Planning Commission Staff Report

August 10, 2016
Item 5.a.

SUBJECT: P16-0920

PURPOSE: Application for Design Review approval to construct an approximately 6,031-square-foot, two-story single-family residence with an approximately 699-square-foot attached garage and an approximately 2,703-square-foot basement

Figure 3: Site Plan

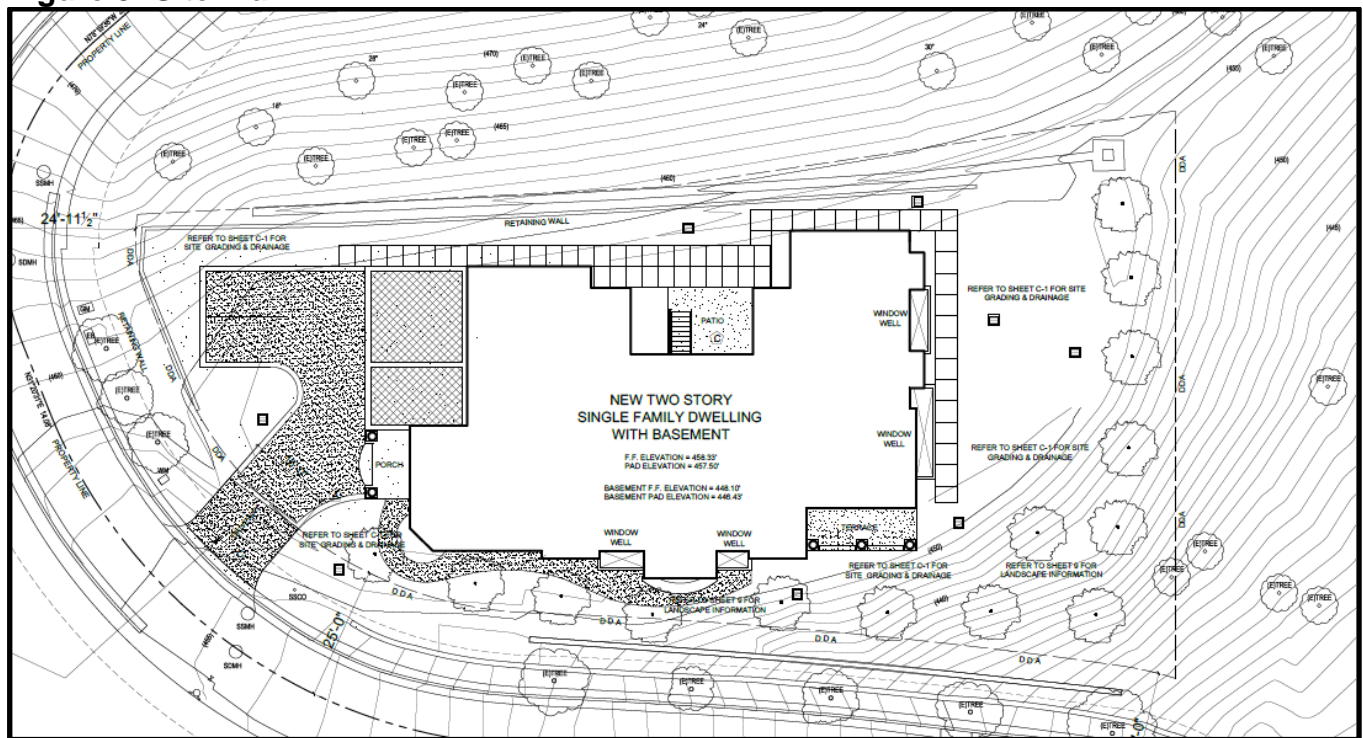
The proposed home is sited completely within the DDA area, as required. The DDA is fairly flat in relation to the other portions of the subject lot, which reduces the amount of grading necessary to accommodate the footprint of the home. By orienting the driveway approach within a flat portion of the site, minimal grading would be necessary to provide access from Winding Oaks Drive.
